Addendum No.2
to
CONSTRUCTION DOCUMENTS
for

June 2, 2025
2023159.00

NCISD New District Administration Building
21330 Valley Ranch Parkway
New Caney, TX. 77357
June 2, 2025

A-158

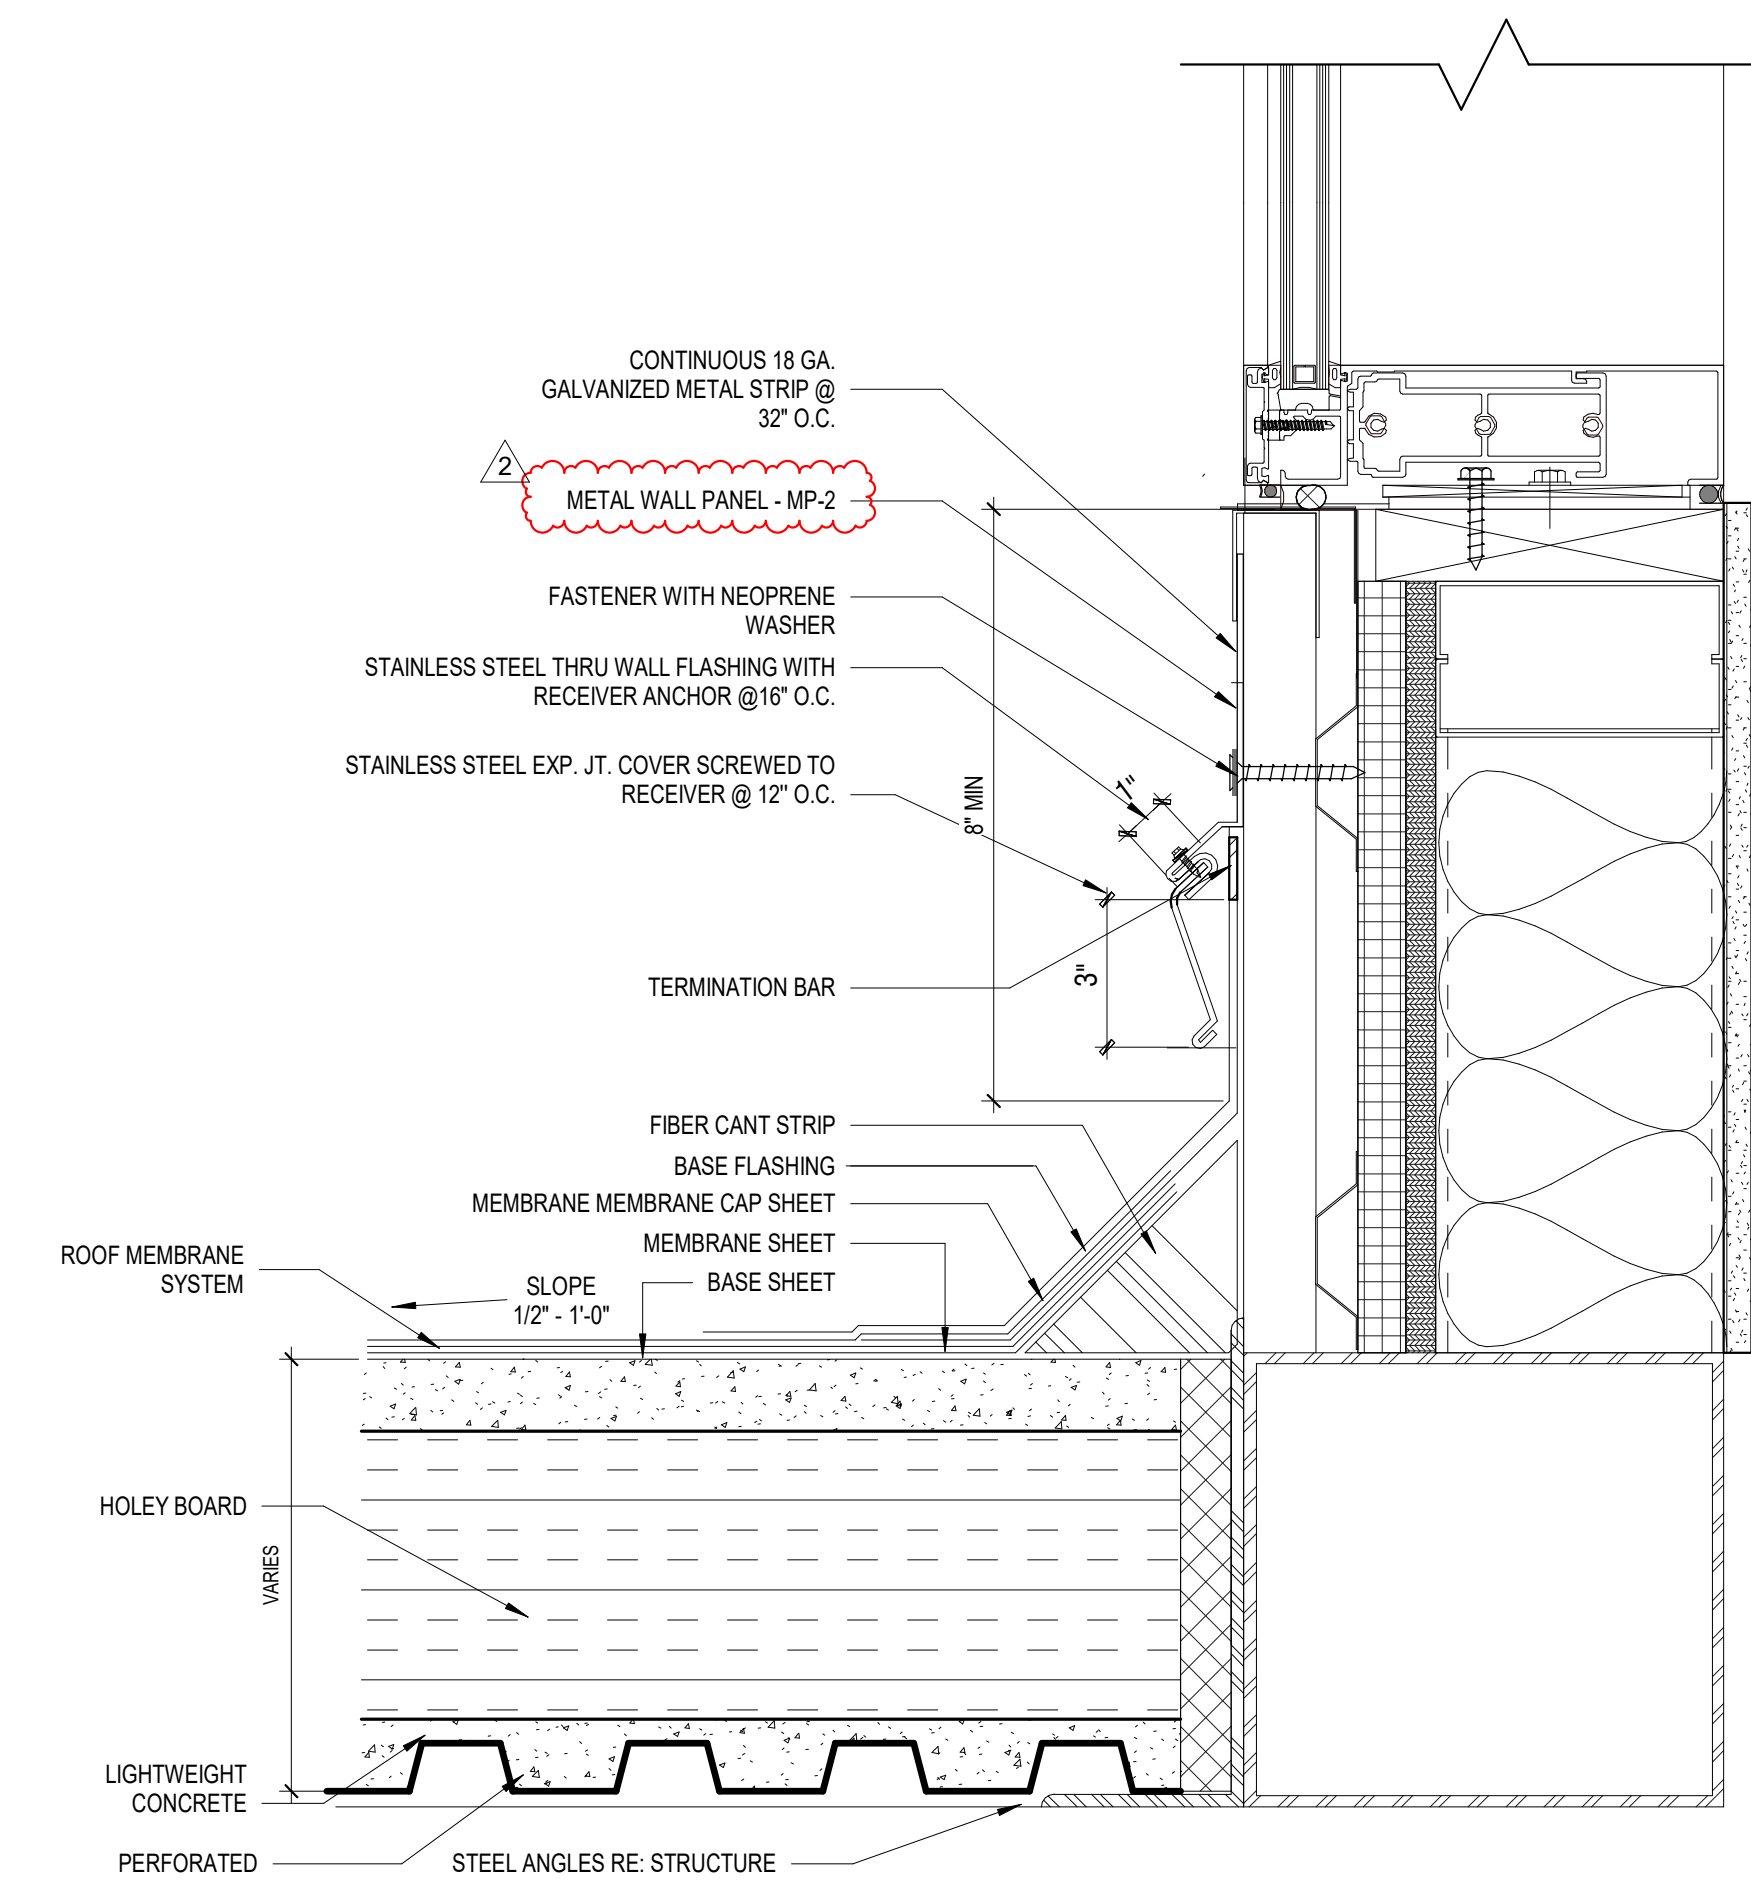
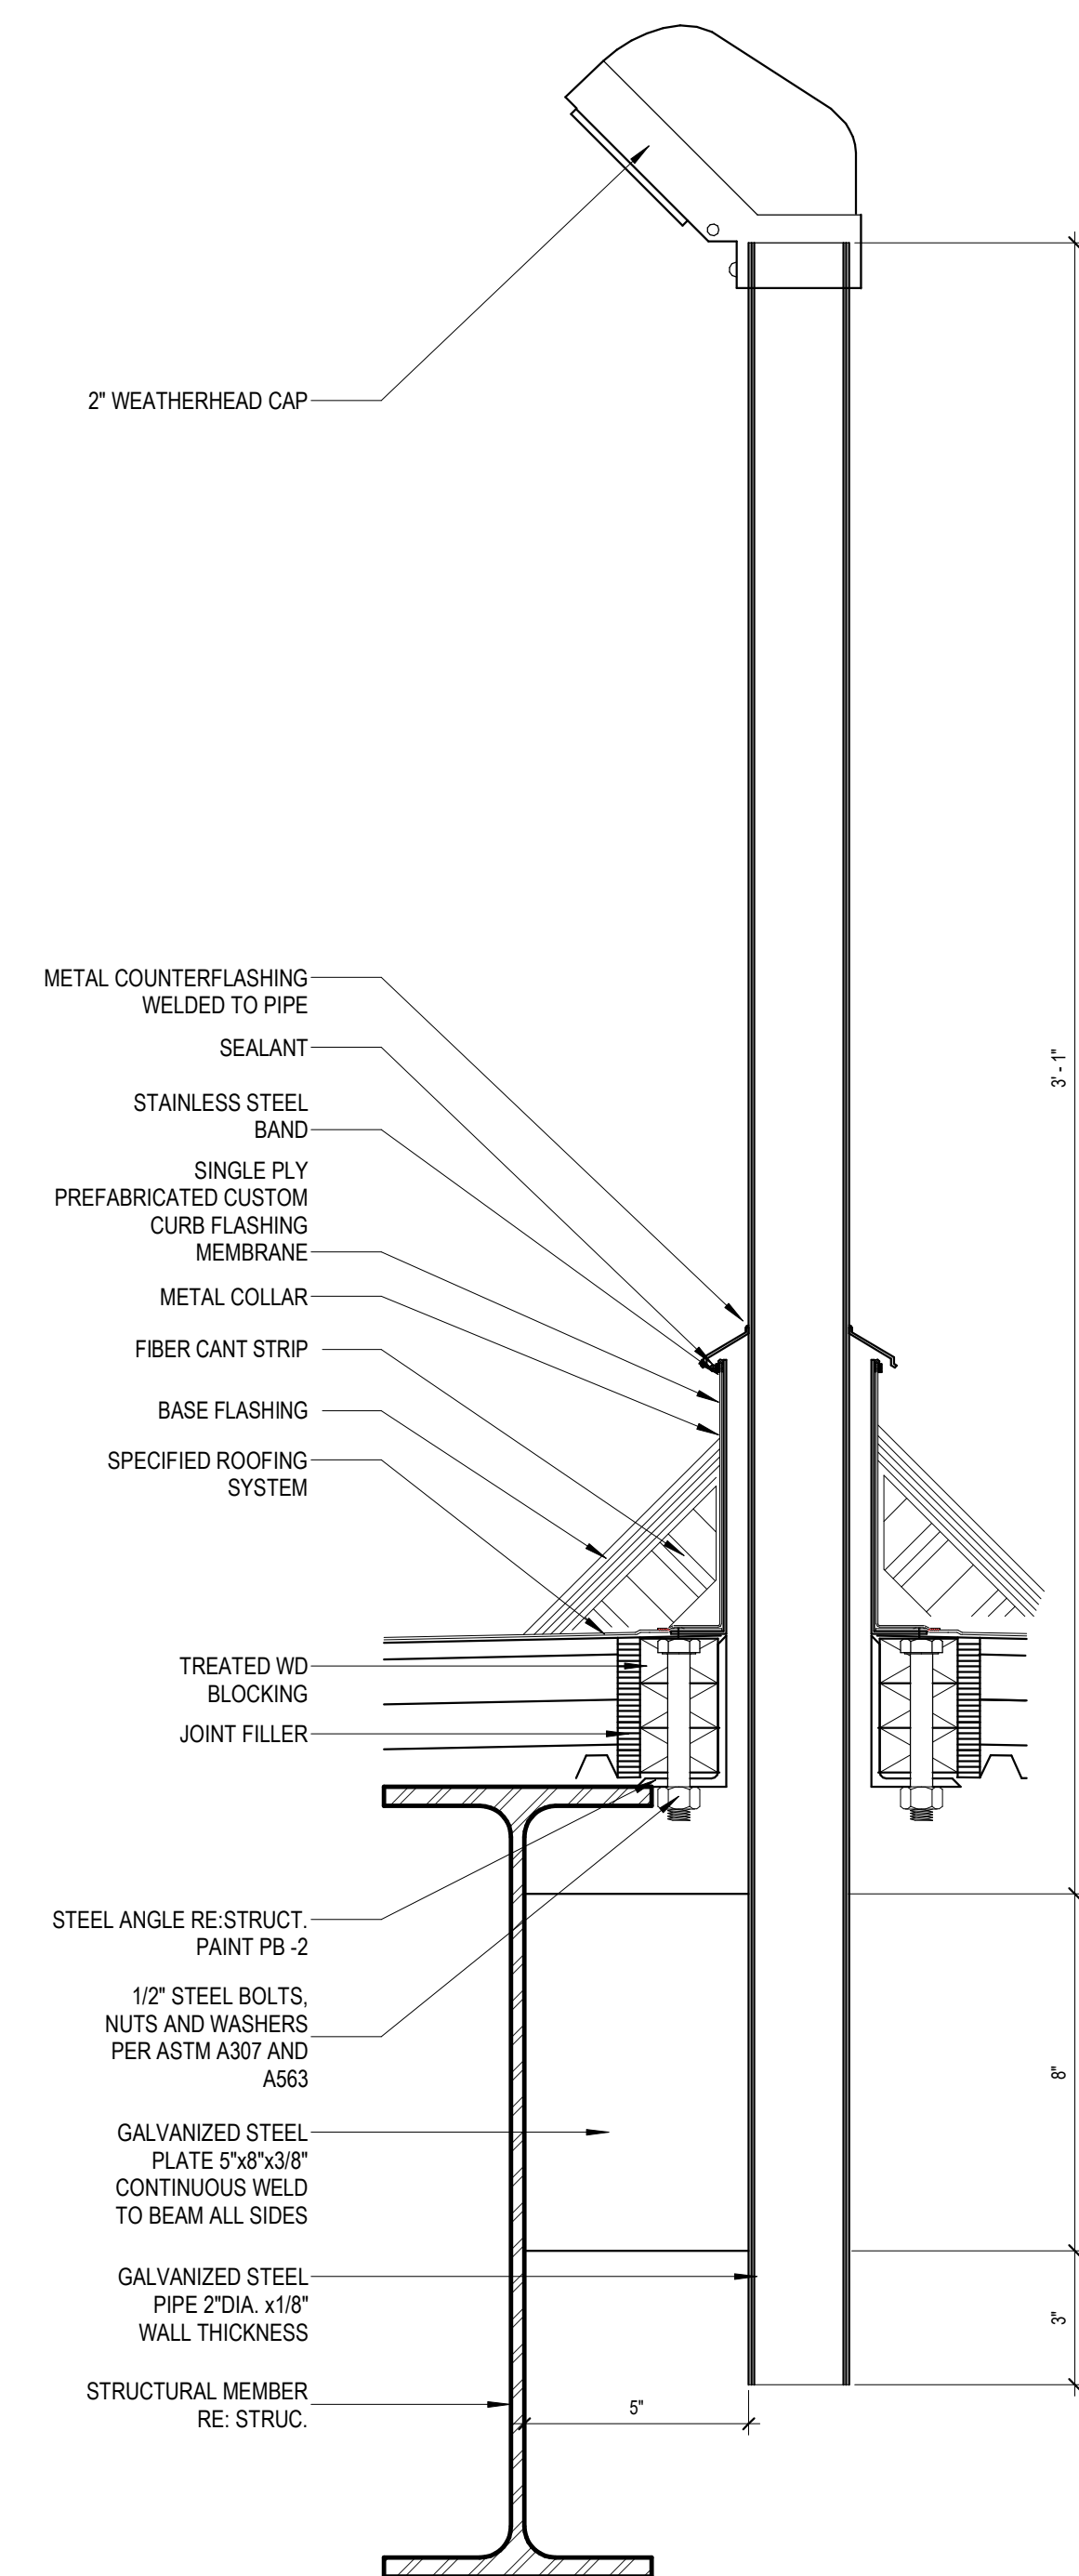
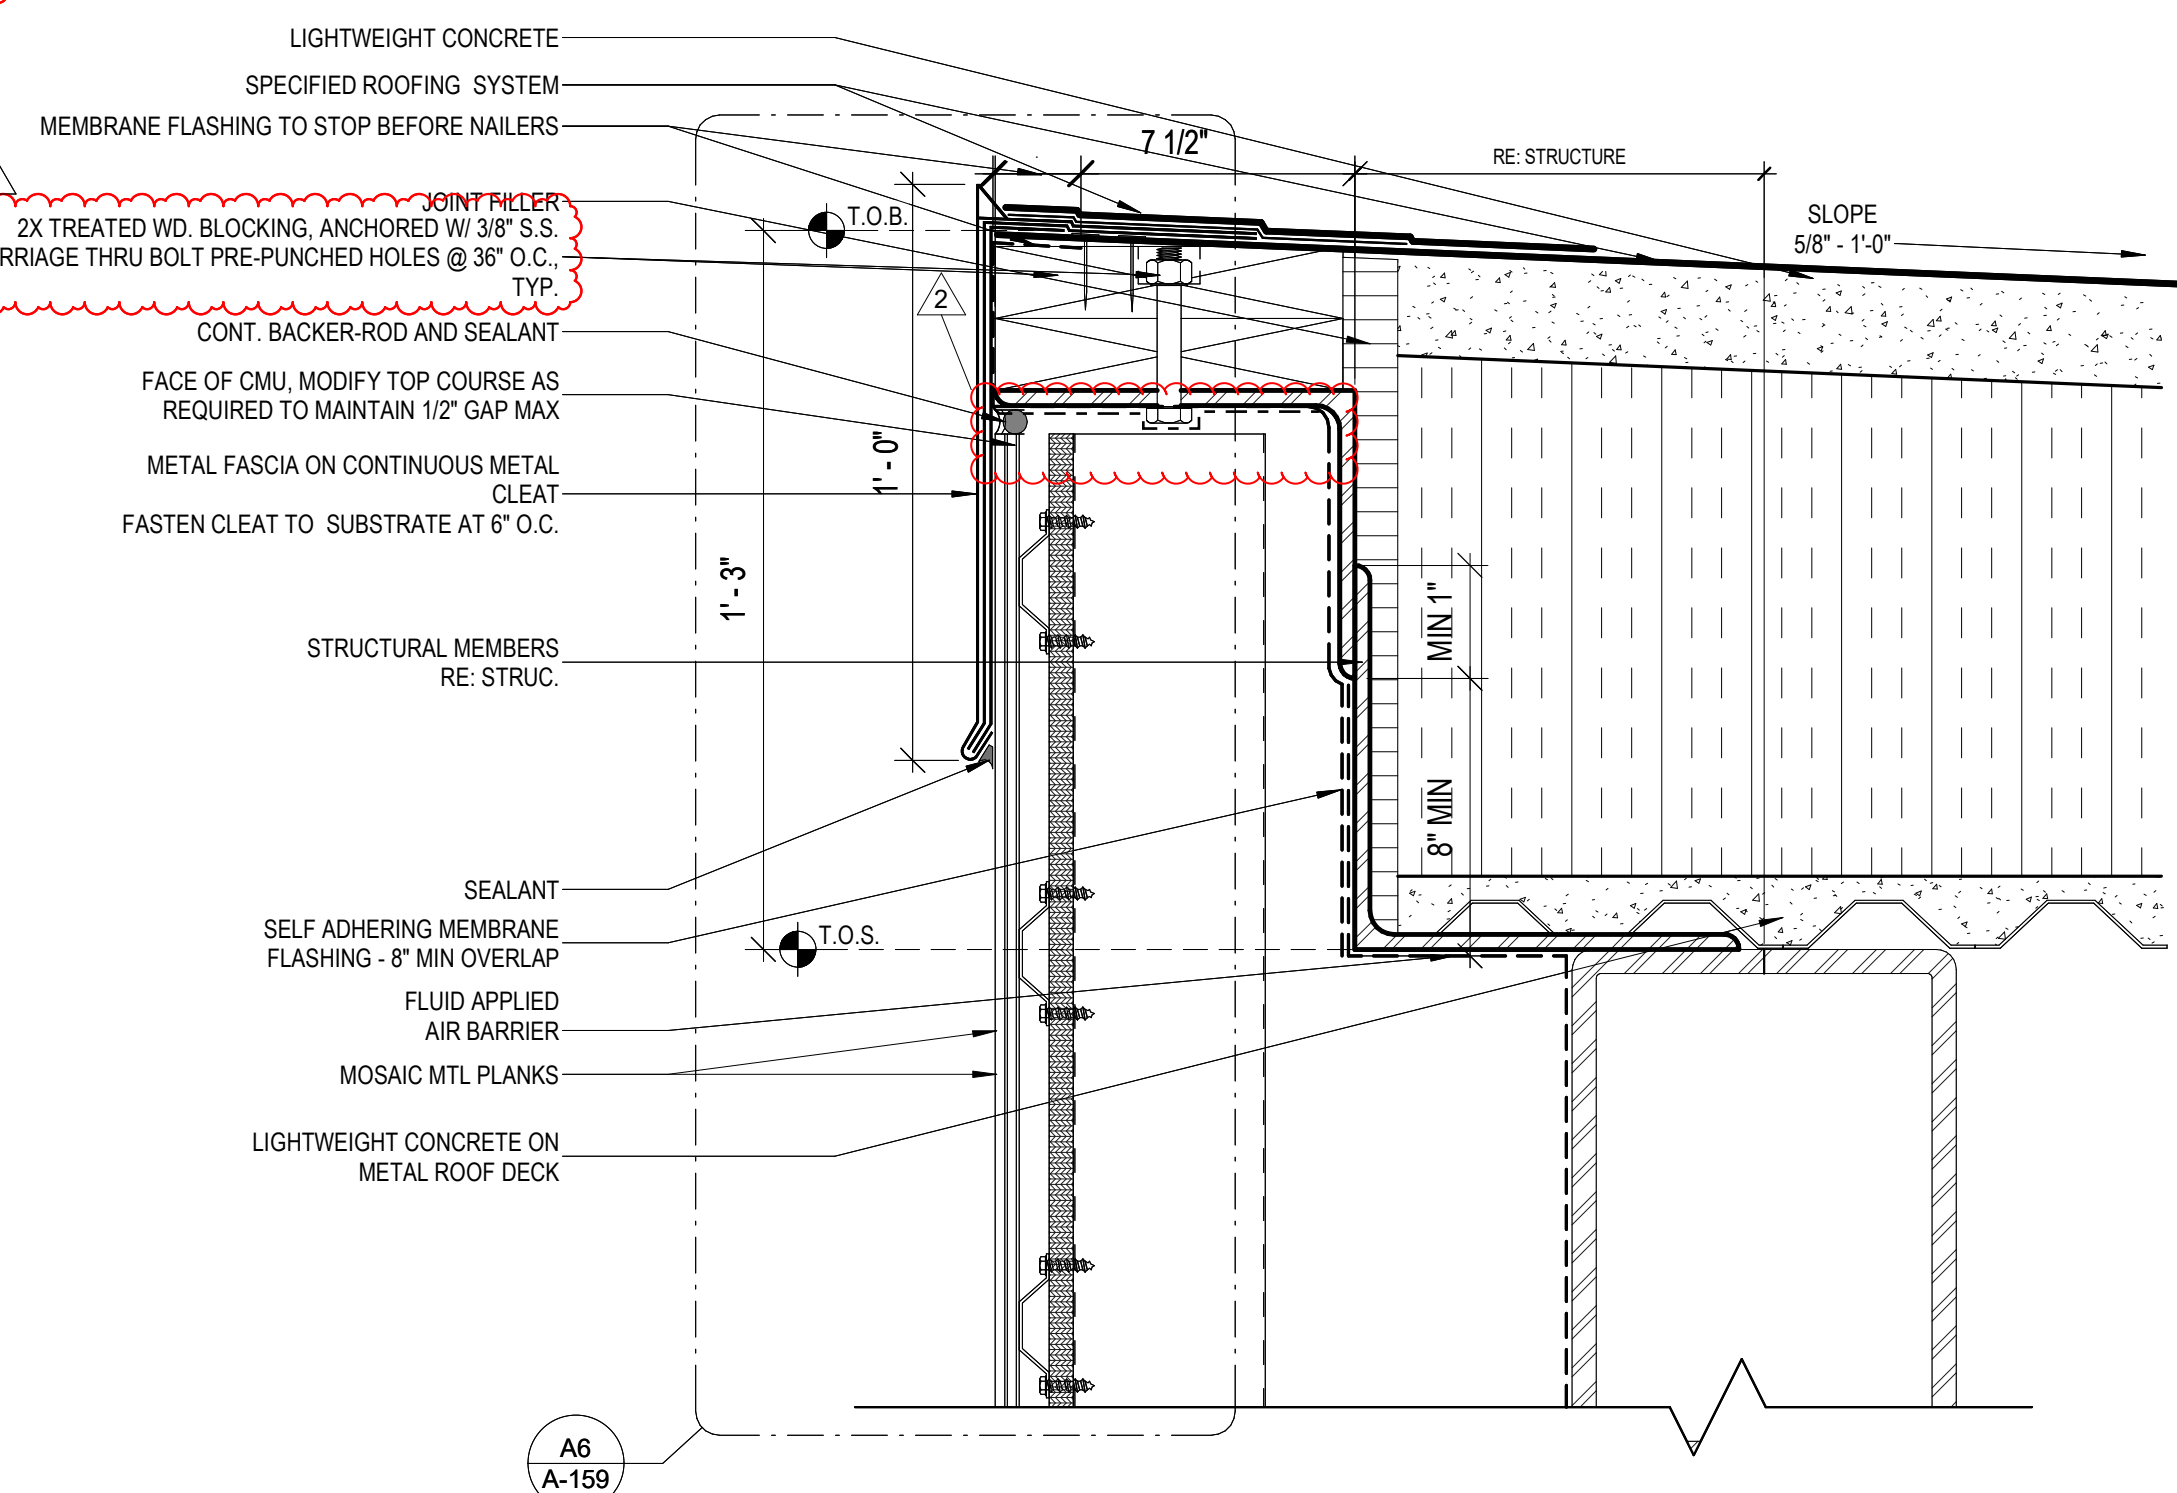
- a. Refer to revised details A2, A3, A4, C1, C3, C4, D1, D3, and D5.
26. Sheet A-158 – Roof Details
- a. Refer to revised details A1, A3, A5, C1, and C5.
